REMARKS

This is a full and timely response to the Official Action mailed November 17, 2005. Claim 6 has been amended and claims 6-15 remain pending in the application. Reconsideration and reexamination are respectfully considered.

AMENDMENTS TO THE DRAWINGS

FIG. 11

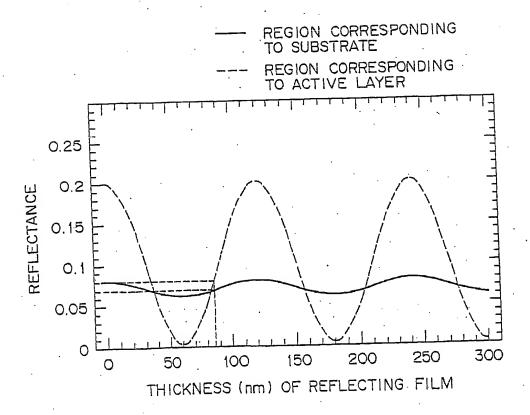
FIG. 11 has been objected to for failing to include the legend "Prior Art", and has been amended accordingly. Applicant respectfully requests reconsideration and withdrawal of the objection to the drawings in light of the amendment.

In Fig. 11- Please add the legend "PRIOR ART"

PRIOR ART"
